AMENDMENTS TO THE DRAWINGS

REMARKS

Title: HIGH VOLTAGE CABLE ASSEMBLY WITH ARC PROTECTION

Docket No.: 14374.111 Serial No.: 10/826,774

Fig. 2B

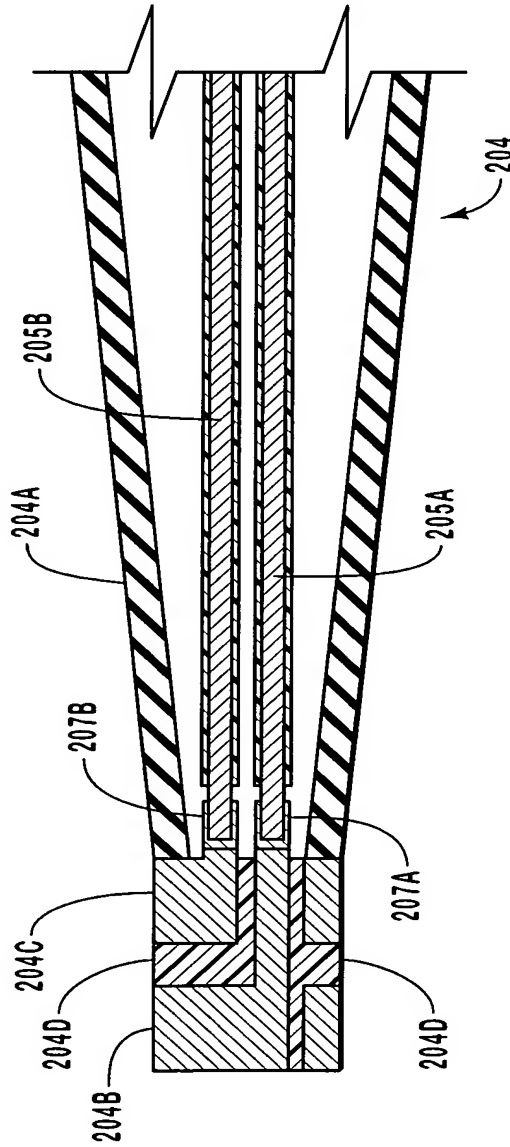
1. *plurality of conductors of a cable*

3. ***plurality of electrical contacts in electrical communication with conductors of the cable***

9. ***plurality of conductive elements within the terminal***

10. ***conductive elements in electrical communication with the conductors of the cable***

11. ***plurality of contacts in electrical communication with the conductive elements***

In light of the addition of Figure 2B herein, showing conductors 205A and 205B, Applicant submits that the objection as to this feature should be withdrawn.

Applicant submits that in light of the addition of Figure 2B herein, illustrating electrical contacts 204B and 204C in electrical communication with conductors 205A and 205B of a cable, the objection as to this feature should be withdrawn.

Applicant submits that in light of the addition of Figure 2B herein, illustrating a plurality of conductive elements 207A and 207B disposed within the terminal 204, the objection as to this feature should be withdrawn.

Applicant submits that in light of the addition of Figure 2B herein, illustrating conductive elements 207A and 207B in electrical communication with the conductors 205A and 205B of the cable, the objection as to this feature should be withdrawn.

Applicant submits that in light of the addition of Figure 2B herein, illustrating a plurality of contacts 204B and 204C in electrical communication with the conductive elements 207A and 207B, the objection as to this feature should be withdrawn.

Fig. 3A

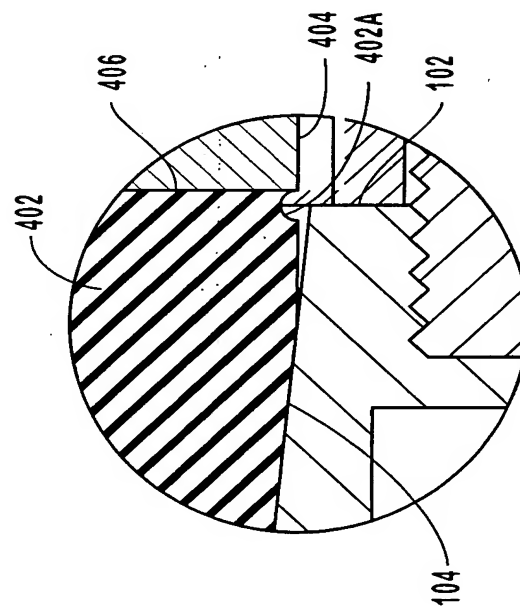
4. ***annular groove proximate the joint***

5. ***annular groove to be an ellipse or circle***

Applicant disagrees with the Examiner and notes that Figure 3A, for example, clearly shows an annular groove 402A located proximate the joint 406. Applicant accordingly submits that the objection as to this feature should be withdrawn.

Applicant disagrees with the Examiner and notes that Figure 3A, for example, indicates that in one embodiment, the cross-section of the annular groove 402A comprises a portion of a circle, moreover, claim 7 has been amended to remove the reference to an elliptical cross-section. Applicant accordingly submits that the objection as to this feature should be withdrawn.
